Planning Application Ref: BE/64/19/T

Location: Fairmead, Shripney Road, Bognor Regis, PO22 9NZ

Description of works: Crown lift by 4m and reduce height & laterals by 3.5 - 4m to 1no. ash tree

Figure 2 Positions of final cuts

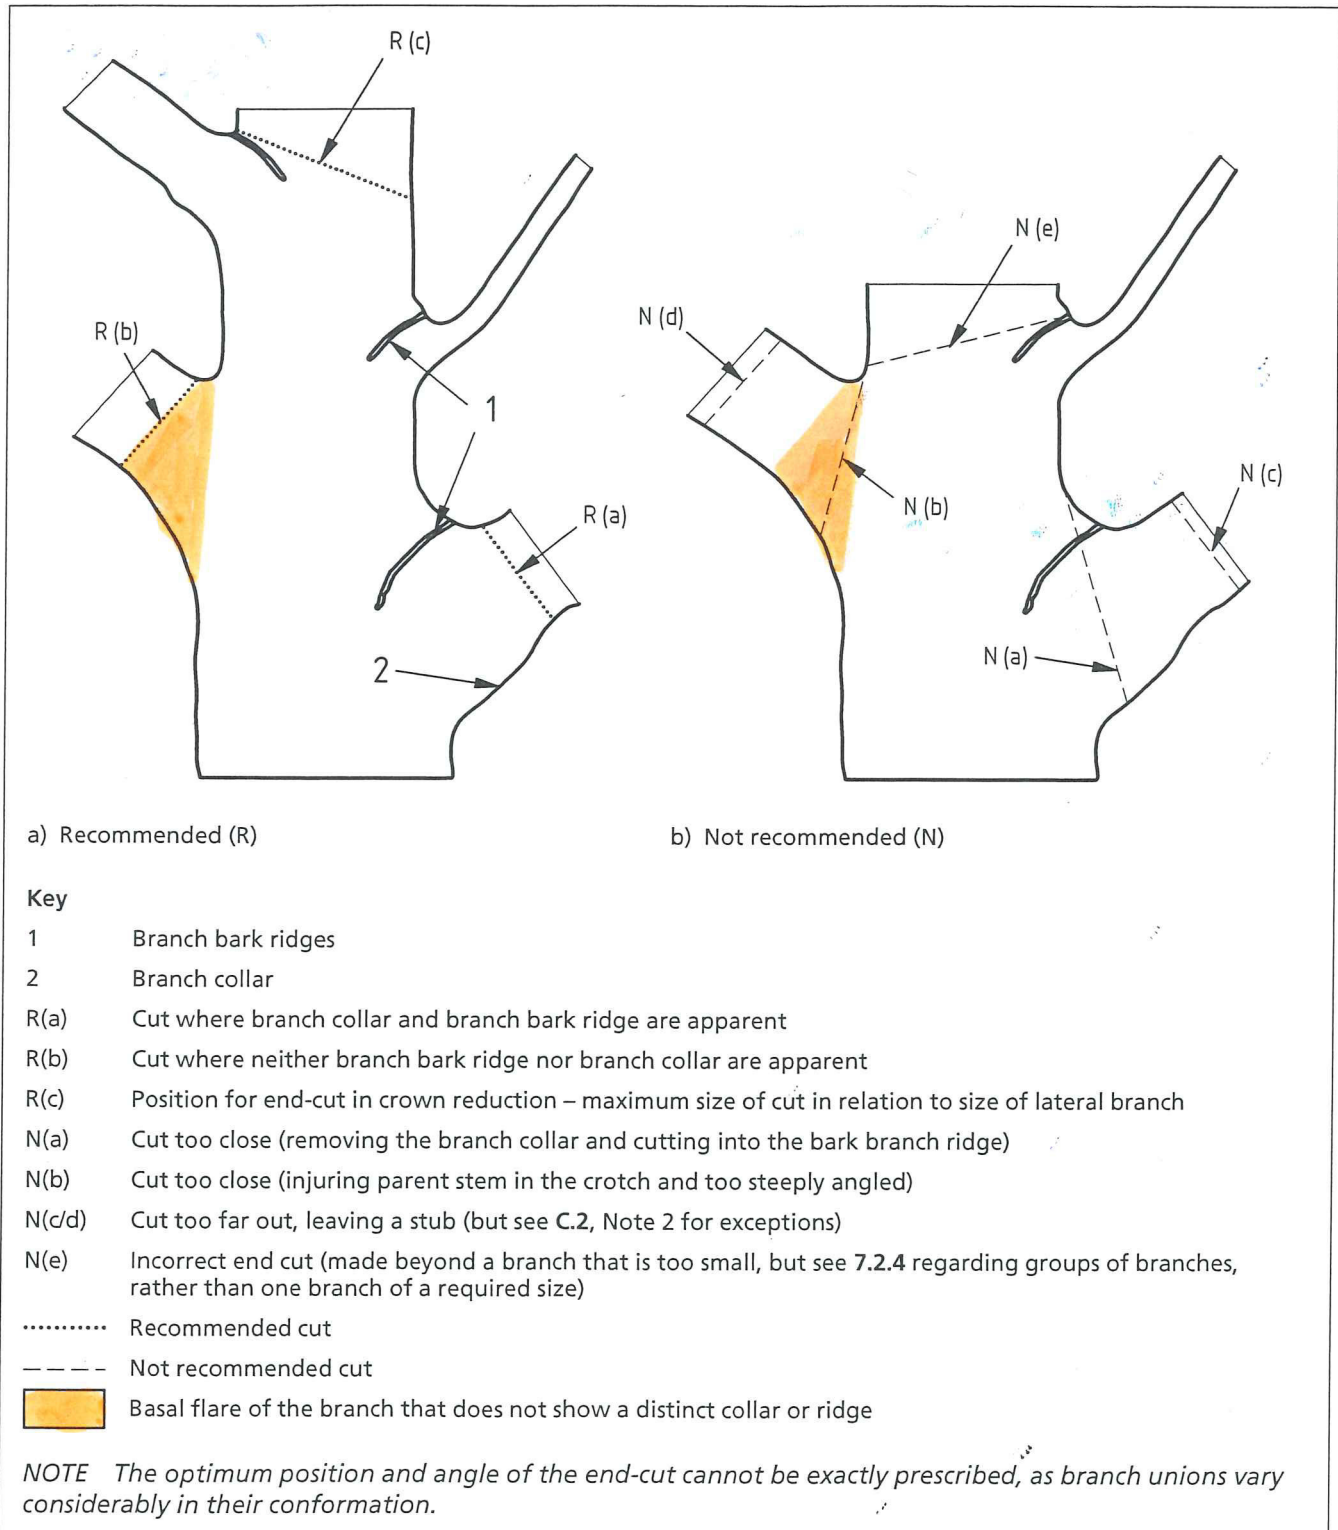
- Where whole branches are to be removed and final cuts made close to the trunk or branch union they are to be made as shown in Figure 2 of BS3998:2010
